COLLEX405INVENTORYMARKEDPLAN

CARDINAL

CARDINAL REVISION LIST - STRUCTURAL:

CARDINAL REVISION LIST - ARCHITECTURAL:

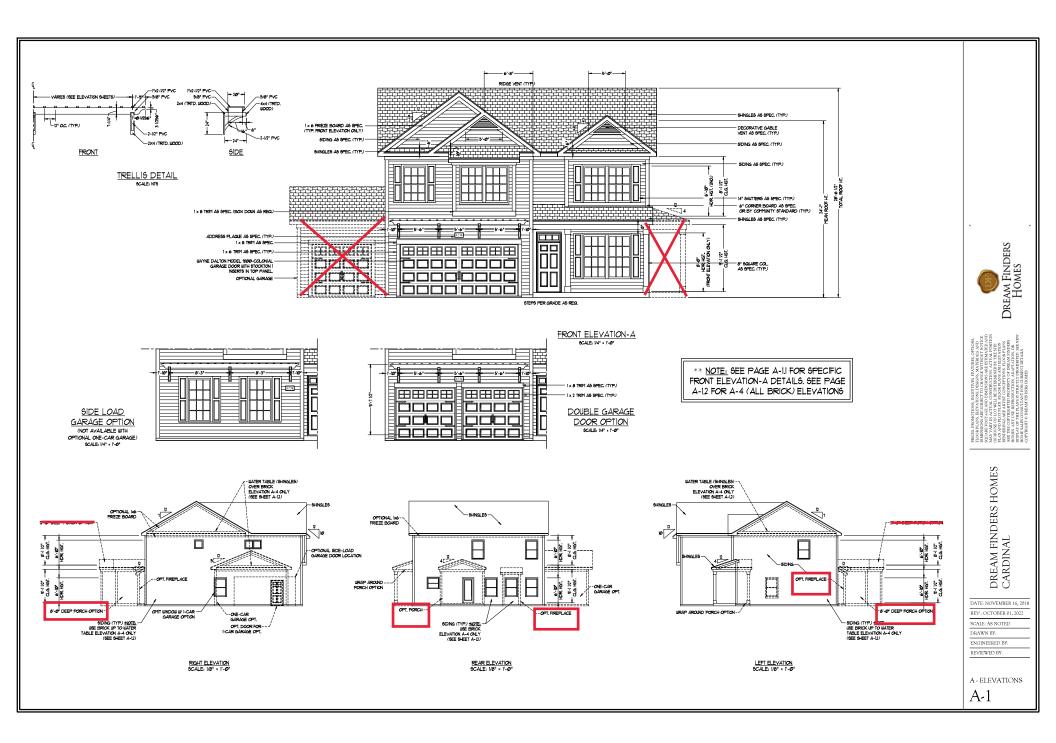
CHANGES ON 10-01-22

- 12. ADDED OPTIONAL 3/0 5/0 WINDOW TO SIDE OF HOUSE IN DINING ROOM
- 13. ADDED OPTIONAL DOUBLE OVEN TO KITCHEN FOR "GOURMET KITCHEN"

CHANGES ON 10-26-22

- 14. REMOVE CLOSET FROM FOYER
- 15. ROTATE POWDER AND PANTRY
- 16. MOVE DOOR IN KITCHEN, REMOVE ADJACENT 3/0 x 3/0 WINDOW
- 17. EXTEND THE KITCHEN COUNTERTOP AND LARGER ISLAND OPTION
